# TECHNICAL REVIEW OF DRAFT ENVIRONMENTAL IMPACT STATEMENT

## Long Island Rail Road Expansion Project Villages of Floral Park, New Hyde Park and Garden City, New York

The Vertex Companies, Inc.  
400 Libbey Parkway  
Weymouth, MA 02189  
781-952-6000

**VERTEX Project No: 43124**  
**February 14, 2017**

**Figure 3.1 – 115 New Hyde Park Road**

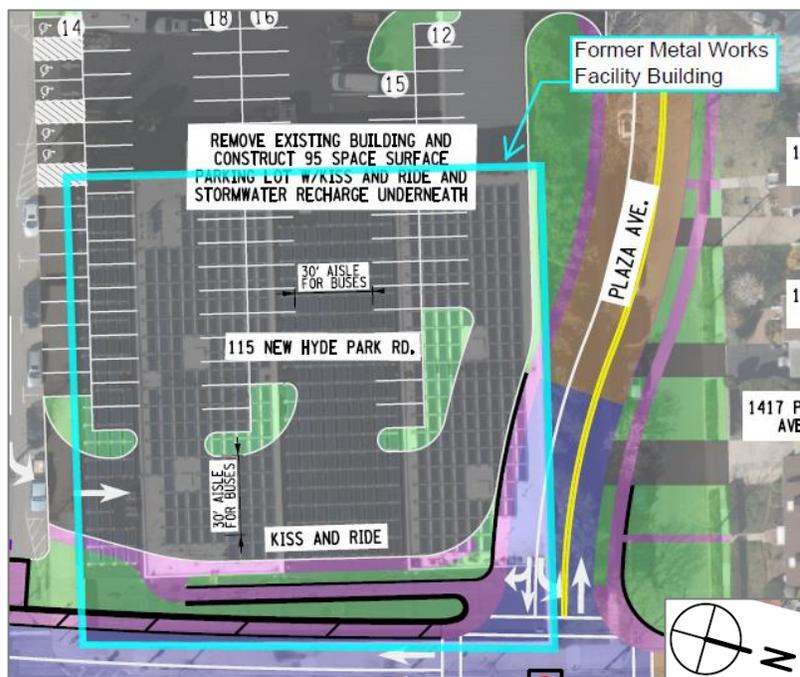
- **New Hyde Park Road Grade Crossing Elimination (New Hyde Park)** – One of the design options for the grade crossing elimination at New Hyde Park Road (Option 1) includes the acquisition and full demolition of the self-storage building at 115 New Hyde Park Road beginning in November 2017 according to Chapter 13 of the DEIS. Once the structure is demolished, an excavation to a depth of up to 31 feet will be completed at the parcel, planned to begin in spring

2018. According to Chapter 8 of the DEIS, 115 New Hyde Park Road is a Category B site (#156) due to the historic presence of a metal works facility at the parcel, as depicted in the 1950 through 1969 Sanborn Fire Insurance Maps. According to the Nassau County Land Records Viewer, the current self-storage structure at the parcel was constructed in 1946 and, therefore, present at the time of metal works operations. Given the absence of reported releases identified for the parcel address in the DEIS regulatory records search and the presence of the historic structure on the majority of the parcel footprint, it is likely that no significant subsurface investigation and/or excavation has been performed since the cessation of industrial activities at the parcel. However, despite the historical use of the site, no soil or groundwater data for the parcel or surrounding properties was included in the DEIS. An annotated detail from DWG GCC04 (Page 169 of DEIS Appendix 1-A) showing the location of the current building (former metals works facility) in relation to the proposed Project construction plan is provided as Figure 3.1.

According to the DEIS, a subsurface investigation will be conducted at all of the acquisition Category B sites. Even though 115 New Hyde Park Road is stated to be a known acquisition Category B site, there is no information provided to suggest that due diligence activities, including a subsurface investigation, are identified to have been initiated at this parcel. As such, the schedule for the Proposed Project will need to accommodate the due diligence subsurface investigation, regulated building materials (asbestos, lead-based paint, etc.) surveys, the potential incorporation of specific site conditions into a RAP, and the preparation of a CHASP, all before November 2017. These technical and regulatory tasks will need to be complete as will also real estate negotiations and the relocation of the current self-storage customers, etc. Since the current building covers nearly the entire parcel footprint, any pre-demolition subsurface investigation would likely be limited in nature and would need to be supplemented with post-demolition assessment between the completion of building demolition at the end of 2017 and the start of earthwork in early spring 2018. Even if all of these activities were able to be conducted in time to meet the stated schedule,

there would likely be limited time allowed for the surrounding community to be able to review and comment on a RAP and CHASP prior to implementation (As noted earlier, this type of information should have been included in the DEIS). Such review would be needed to allow the neighboring residents and business owners to assess whether concerns they might have including the migration of metals-impacted dusts and the spread of metals-impacted soils by truck tires are properly anticipated and addressed in the construction plans.

**Figure 3.3 – Plainfield Avenue Bridge**

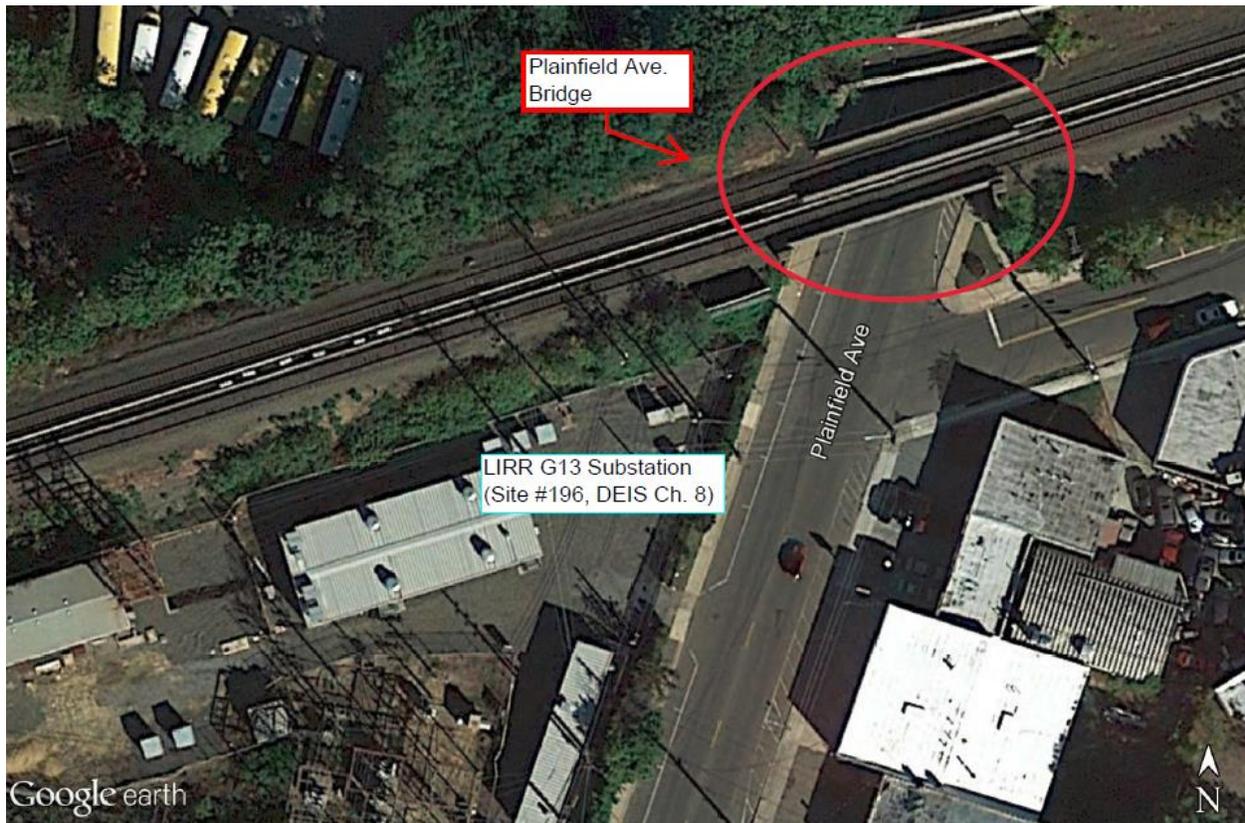
- **Plainfield Avenue Bridge (Floral Park)** – According to Appendix 1-A of the DEIS, an additional bridge over Plainfield Avenue will be retrofitted to accommodate the planned third track. As shown in the Appendix for Chapter 8 of the DEIS, this bridge is located immediately adjacent to site #196, which is the existing Floral Park LIRR G13 substation that is not to be altered during the construction of the Proposed Project. According to the DEIS, site #196 is the subject of subsurface releases being actively addressed by LIRR as part of the Voluntary Cleanup Program. In this case, it is likely that subsurface investigation data in the vicinity of this location associated with the Proposed Project is available for review, and the specific risks to the Village can be determined and mitigated in some manner; however, the DEIS does not include any of this data and this evaluation is therefore not provided in the DEIS. The location of the substation site in relation to the Plainfield Avenue bridge is shown on Figure 3.3.

Figure 6.2

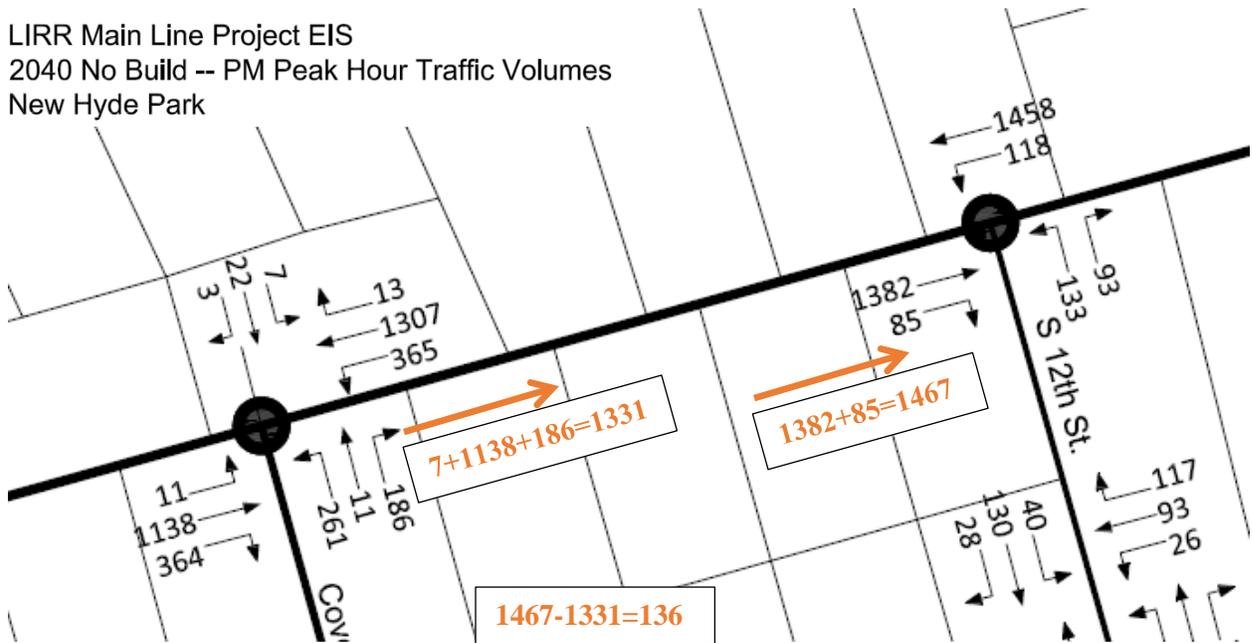
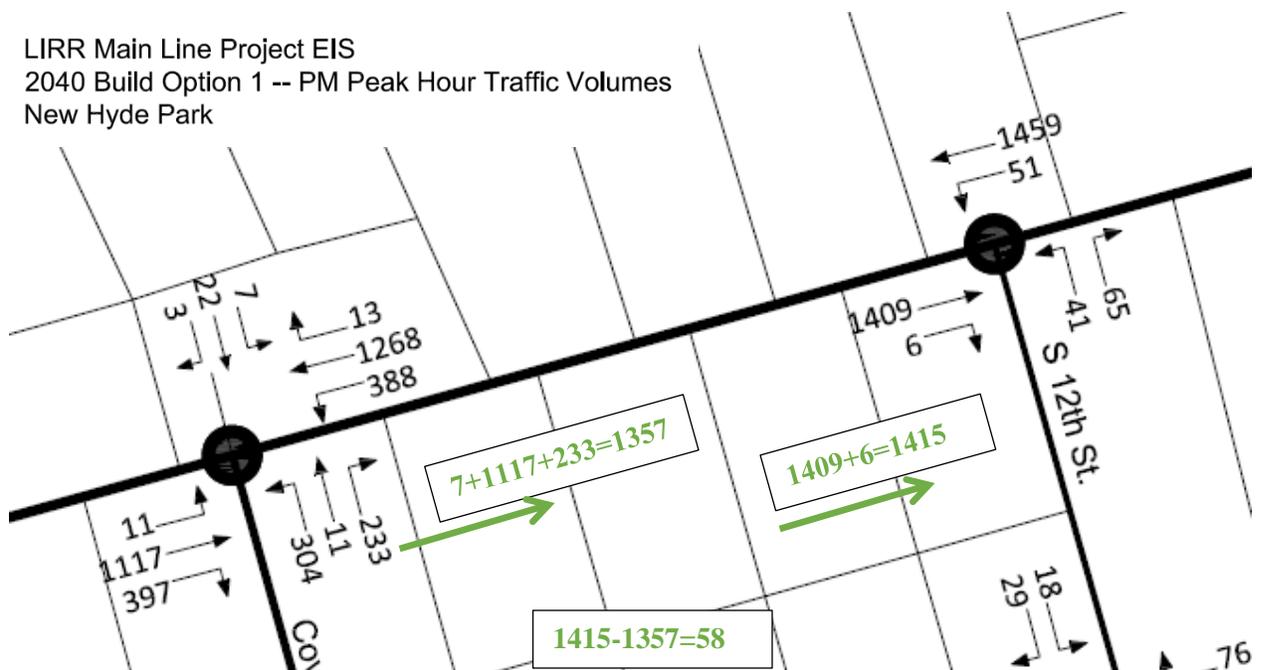
There appears to be major discrepancies in the routing of vehicles when comparing the No-Build Condition to Build Condition peak-hour volumes for the New Hyde Park volume figures (i.e., Pages 12 vs. 19 and 13 vs. 20 of Appendix 10 of the DEIS). Volumes frequently do not track between intersections with vehicles getting 'lost' between study locations. For instance, as indicated in Figure 6.2 and Figure

6.3 the 2040 No Build PM Peak Hour Condition volume figure indicates that 1,331 vehicles leave the intersection of Jericho Turnpike and Covert Ave traveling eastbound ( $7+1138+186$ ) and 1,467 vehicles ( $1382+85$ ) arrive at Jericho Turnpike and South 12th Street eastbound for a net difference of 136 vehicles. In the 2040 PM Option 1 Build Condition, volume figure, the net difference between intersections decreases to 58. ( $1117+233+7-1409-6=58$ ). Either there are numerical errors in the calculations which must be rectified to ensure the conclusions made are valid or traffic is projected to utilize the side streets between Covert Ave and South 12<sup>th</sup> Street, necessitating the need for additional study locations.
